Crossover Guide

Unimotor fm E2/U2 to
Unimotor fm E3/U3

Unimotor fm Servo Motors - E2/U2 migration to E3/U3 models

Unimotor fm E2/U2 Unimotor fm E3/U3

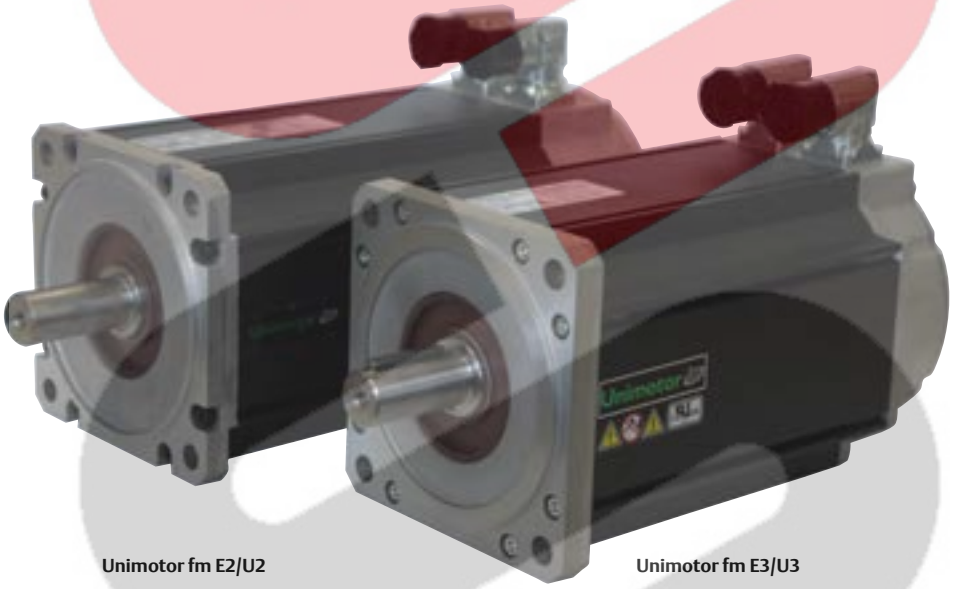
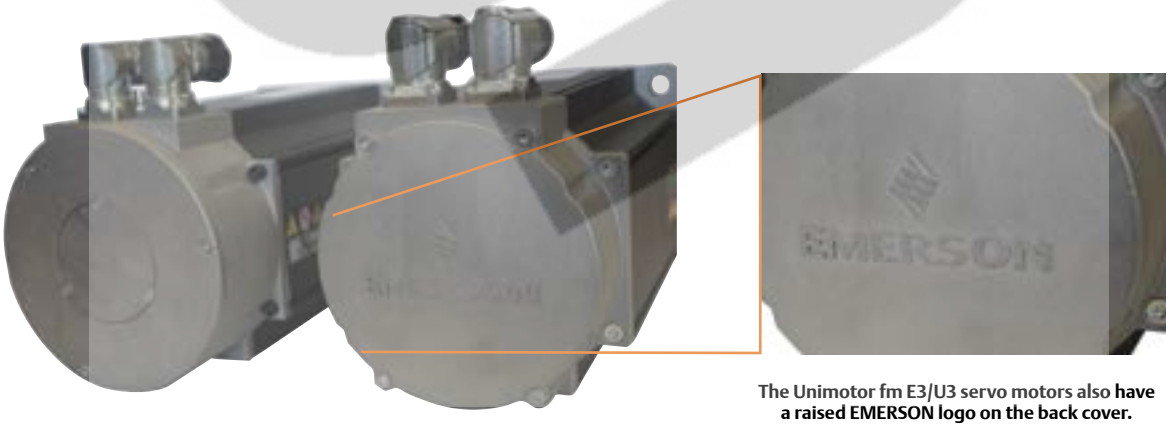
The Unimotor fm servo motor family has recently been redesigned to utilize Emerson Industrial Automation's latest manufacturing and component design improvements. This redesign provides improved performance in a shorter length frame as compared to the previous design.

You will also see in the following information that there are higher performance specifications listed for most frames and lengths. Electrical parameters like, Kt (torque constant) and Ke (voltage constant) remained the same for the new models. This will allow for direct replacement into existing applications with no need to change motor parameters to maintain the existing performance levels. Only instances where increased motor performance levels are desired would changes to drive parameters be needed.

The Unimotor fm E3/U3 servo motors also have a raised EMERSON logo on the back cover.

Connector Position and Motor Length Differences

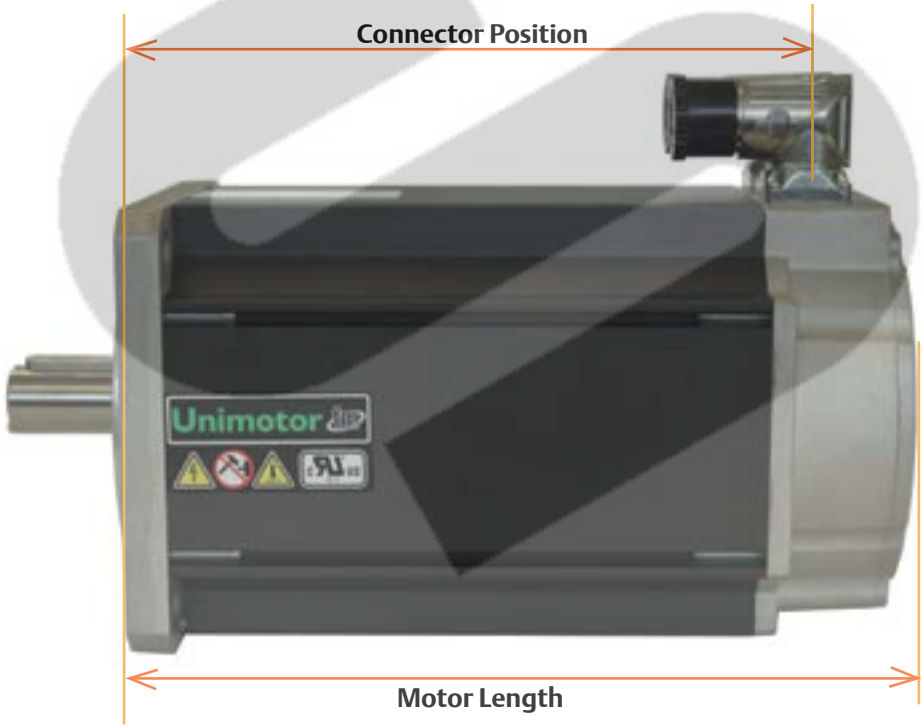
With the new E3/U3 models the motor length decreases on some of the frames. Along with this shorter motor length also comes a difference in the connector position relative to the motor faceplate. With the shorter motor the cable connectors move closer to the motor faceplate.

- With the shorter motor the cable connectors move closer to the motor faceplate
- Along with this shorter motor length also comes a difference in the connector position relative to the motor faceplate
